Project Name: **BRW&S H2GO Administrative and Field Operations Complex (A+FO Complex)**
Adjacent to 146 Gregory Road, NE
Belville, NC 28451

Architect's Project Number: #342302

ADDENDUM NUMBER ONE

03-A2

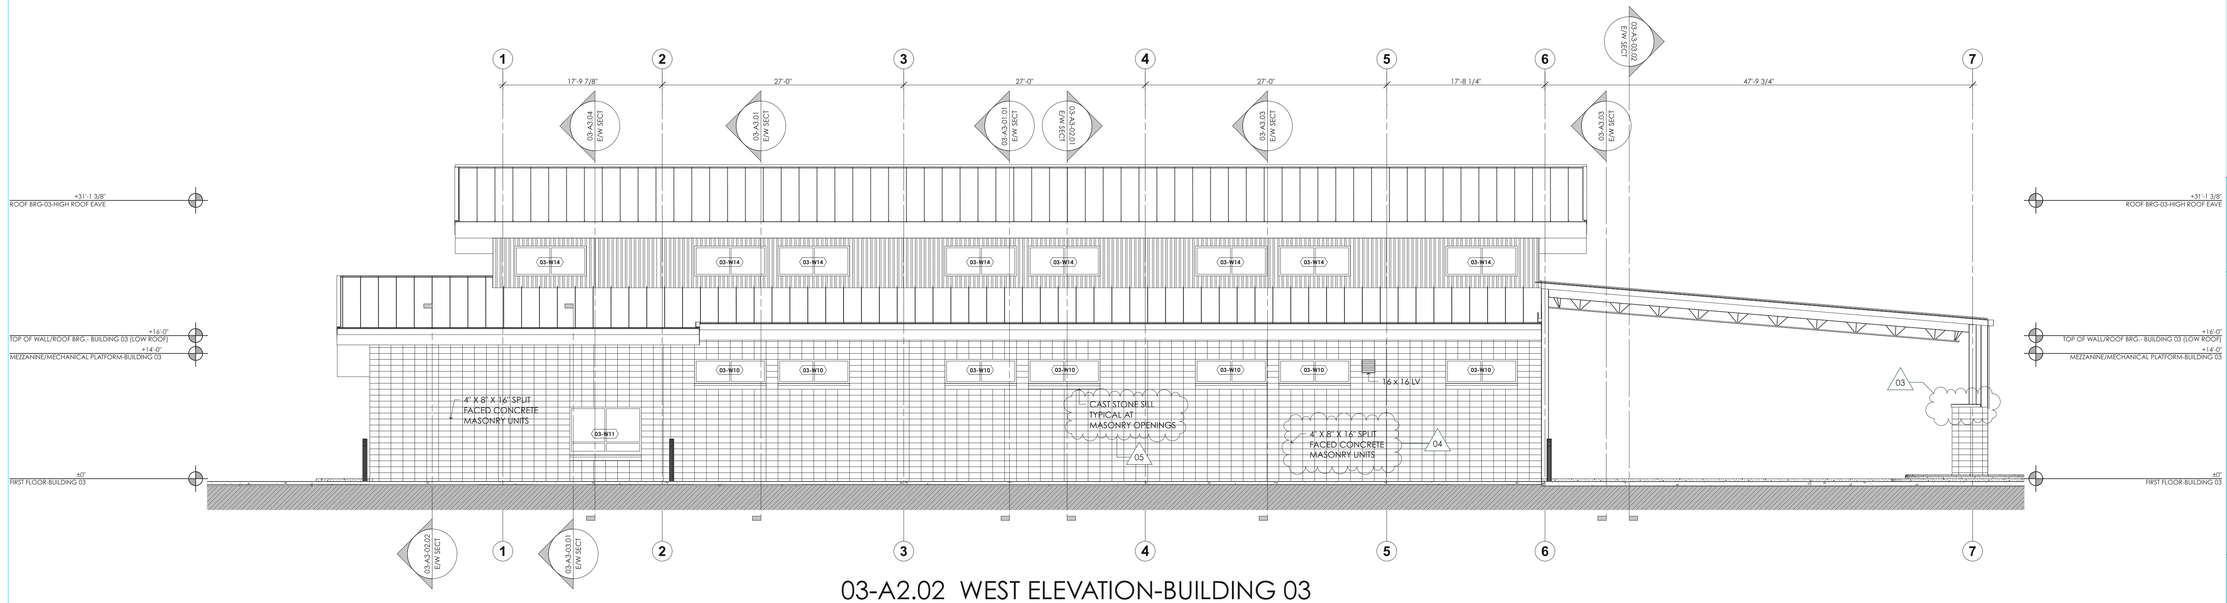
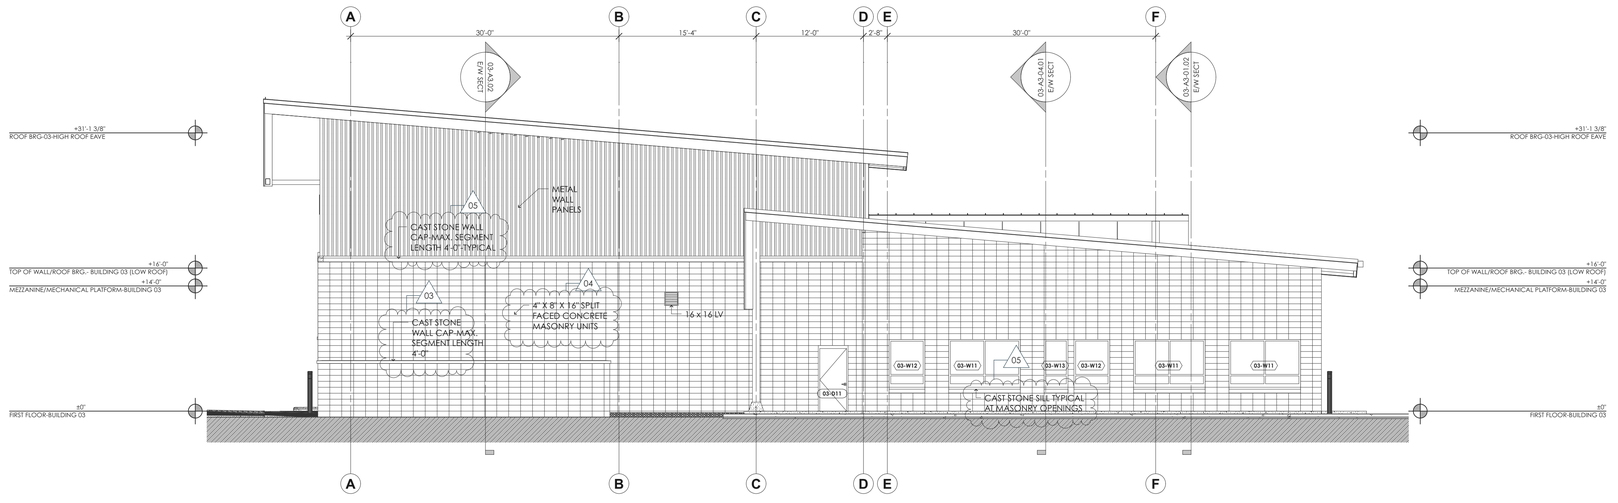
Change 04: Revise Exterior Wall Description. Change description from Ground Faced Masonry (GFM) to Split Face CMU.

Change 05: Add note to provide Cast Stone Sills at masonry window openings.

- **Sheet 03-A1 First Floor Plan:** Changed CMU from 8" to 12" (ID 01), Revised/Add Wall Types (ID 02), and Added Cast Stone Wall Cap (ID 03)
- **Sheet 03-A2 N/W/ Building Elevations:** Added Cast Stone Wall Cap (ID 03), Revised Wall Description (ID 04), and Added Cast Stone Sill Note (ID 05)

03-A2-01

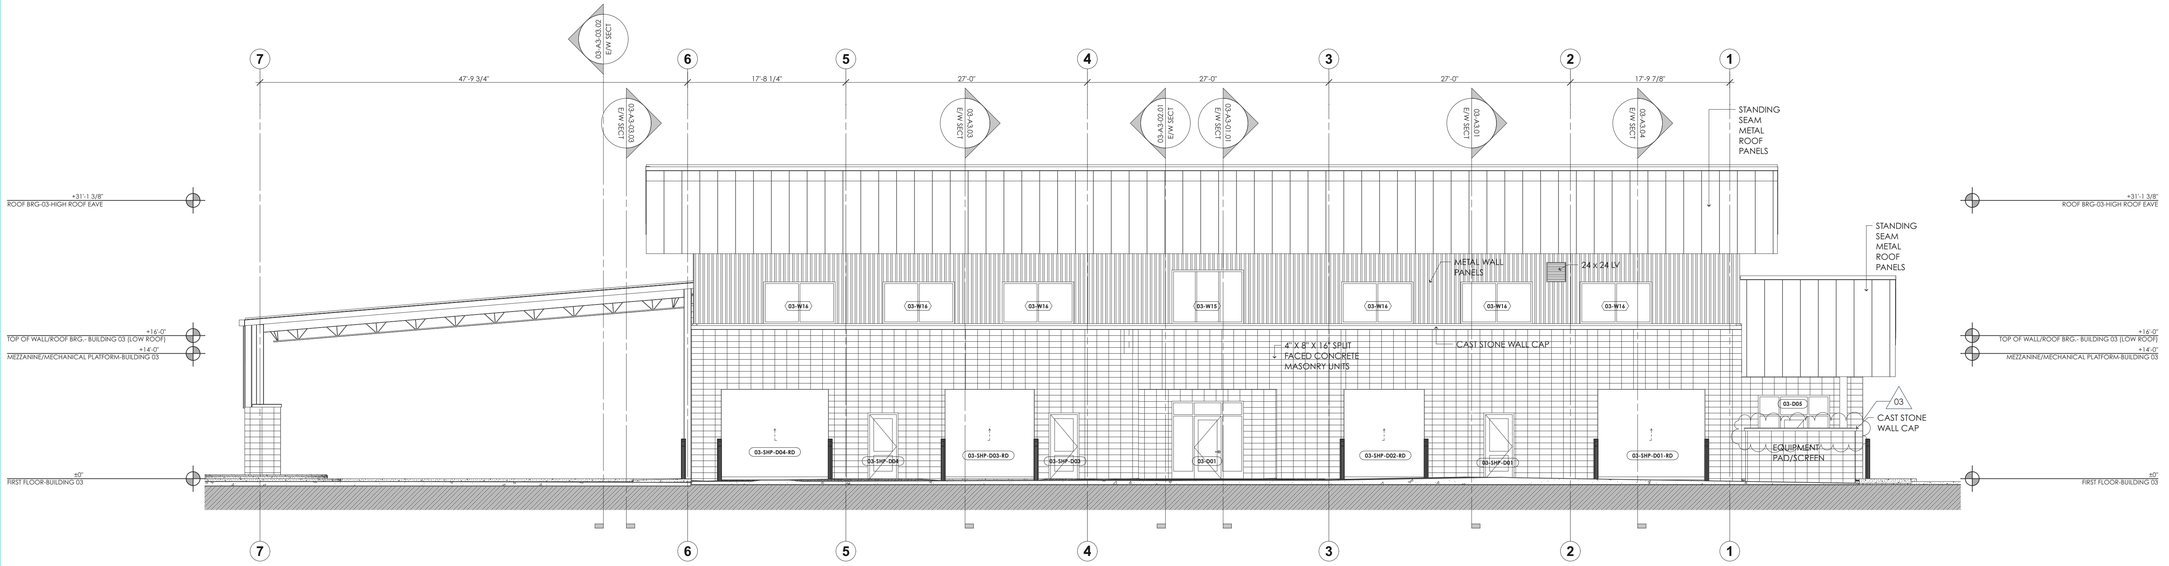
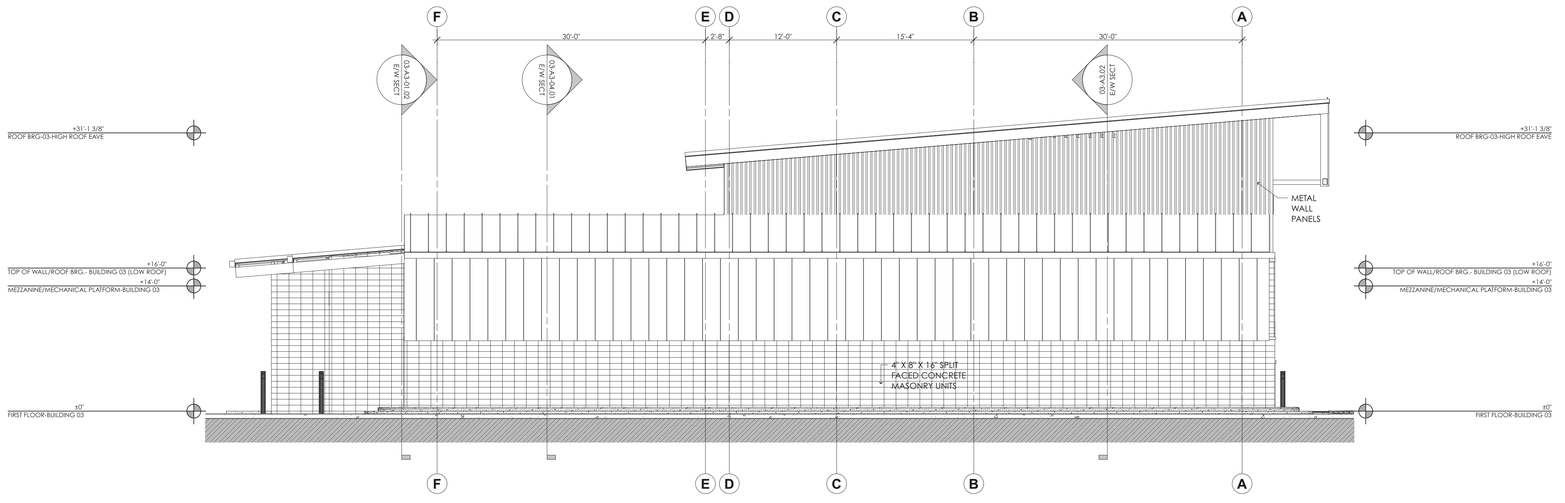
- **Sheet 03-A2-01 S/E Building Elevations:** Added Cast Stone Wall Cap (ID 03)
- **Sheet 03-A3 Building Sections:** Revised and Added Wall Type (ID 02) and Added Cast Stone Wall Cap (ID 03)

03-A3

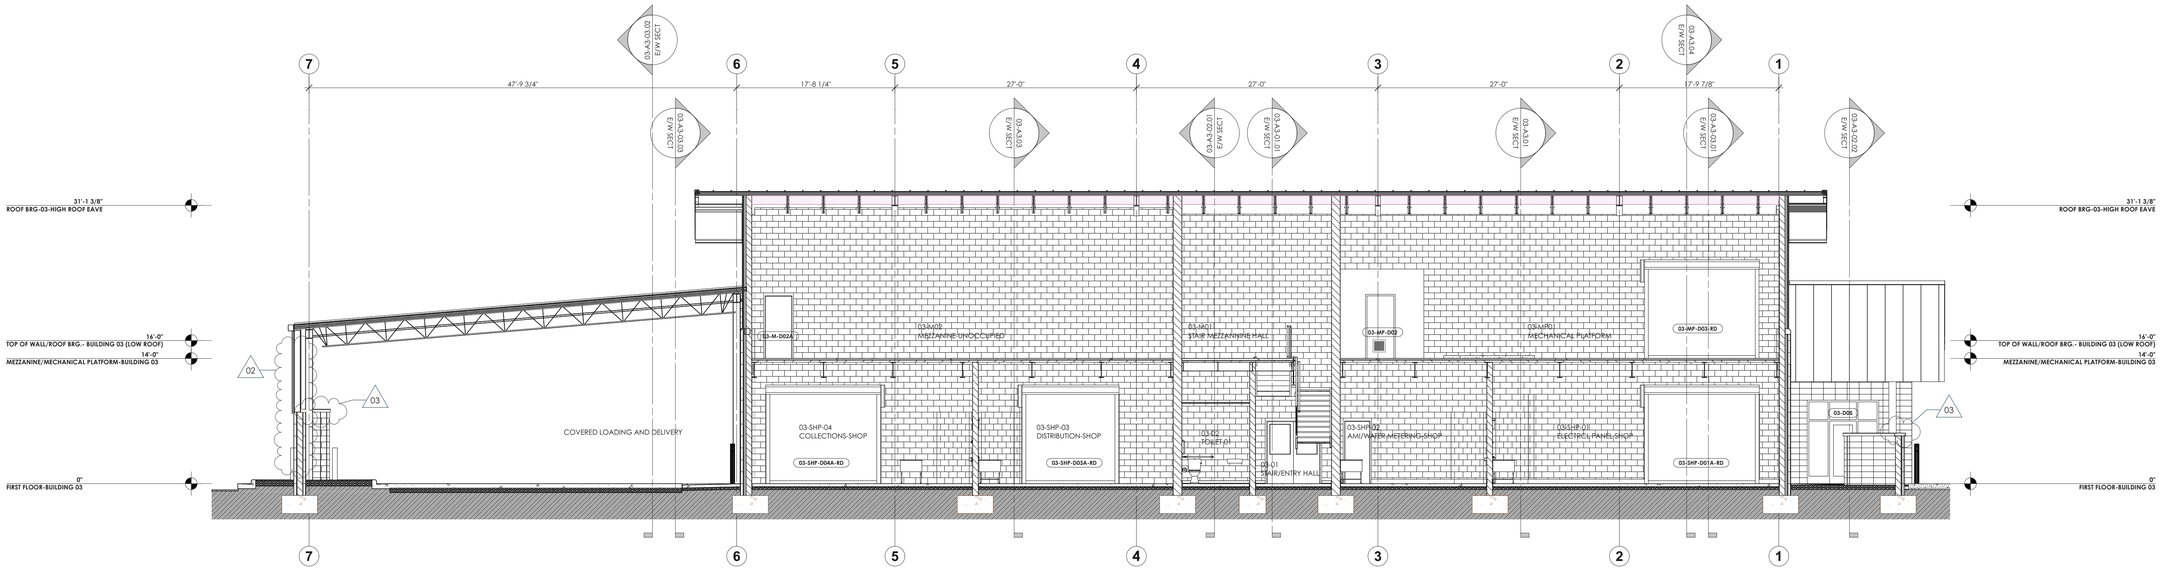
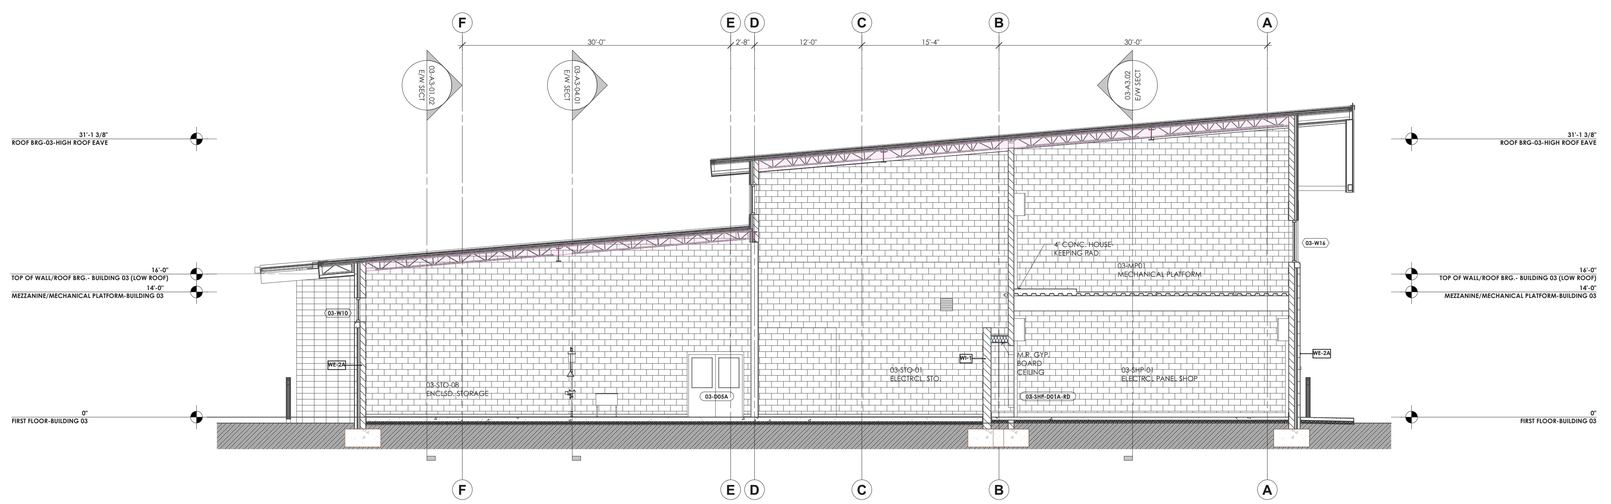
Change 02: Revise original wall type label and add additional wall type on Column Line 7.

Change 03: Add Cast Stone Wall Cap for Wall Type WE-6 at Column Line 7.

03-A3-01

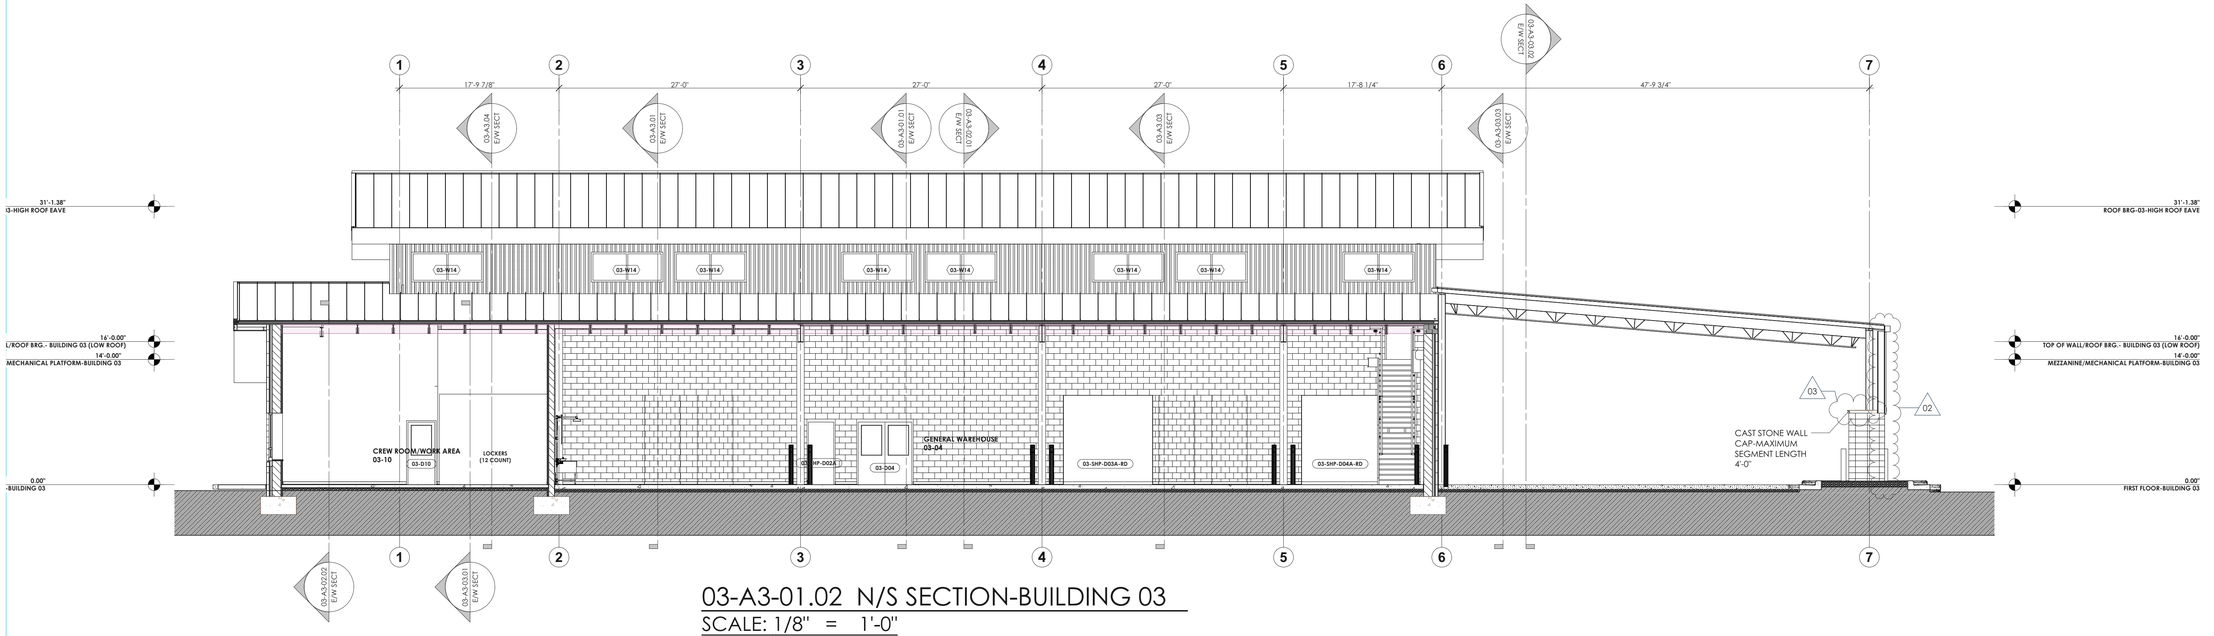
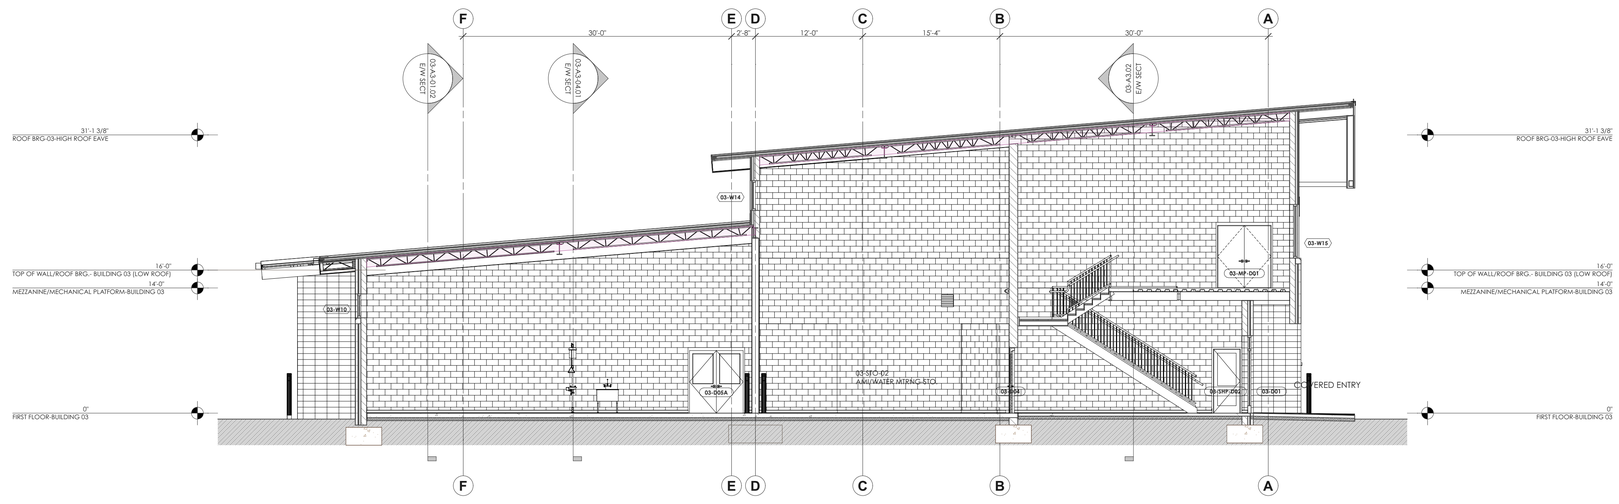
- **Sheet 03-A3-01 Building Sections:** Revised and Added Wall Type (ID 02) and Added Cast Stone Wall Cap (ID 03)
- **Sheet 03-A3-02 Building Sections: Added Cast Stone Wall Cap (ID 03)**

04-A1.02 FINISH SCHEDULE-BUILDING 04

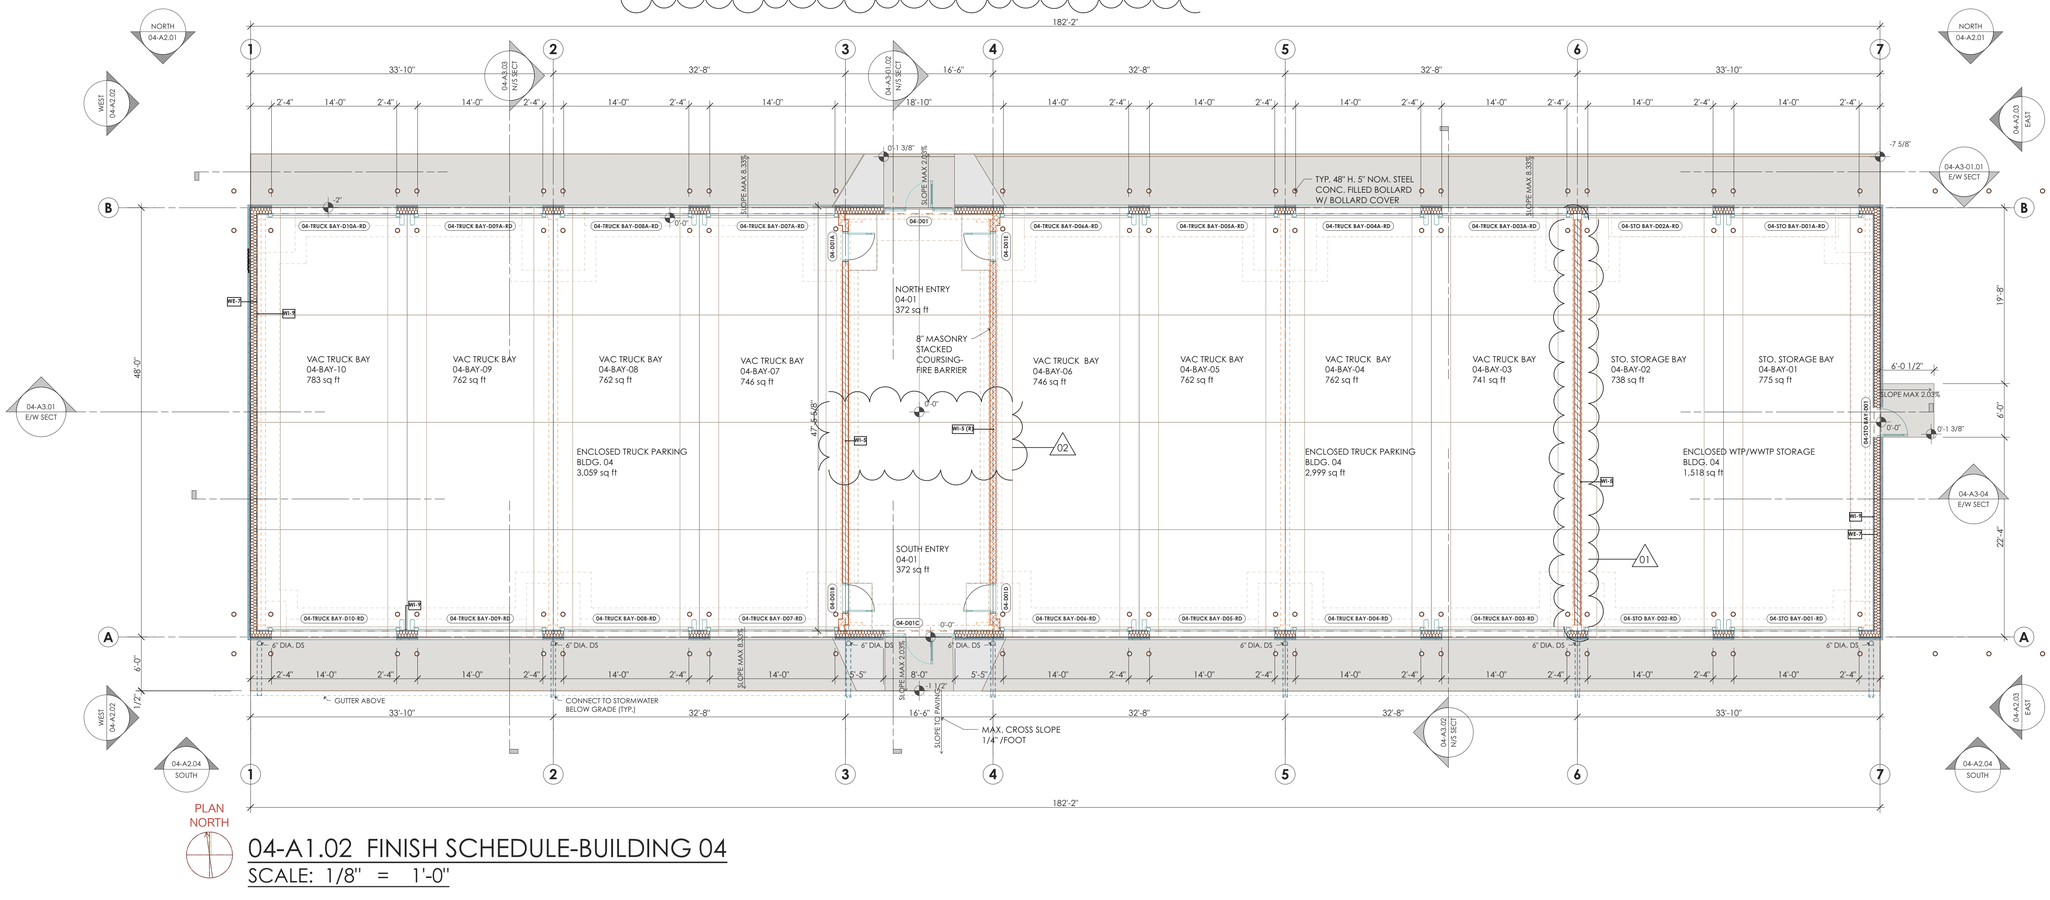
Change 01: Change Wall Type indicated as 8" insulated horizontal girts with metal wall panels each side to Type WI-5.

Change 02: Change wall types for existing interior masonry walls as indicated.

Change 03: Add Wall Type Legend Drawing 04-A1.03.

- **Sheet 04-A1 First Floor Plan – Finish Schedule – Wall Types:** Revised Wall Types (ID 01), Revised Wall Type (ID 02), and Added 04-A1.03 Wall Types Legend (ID 03)
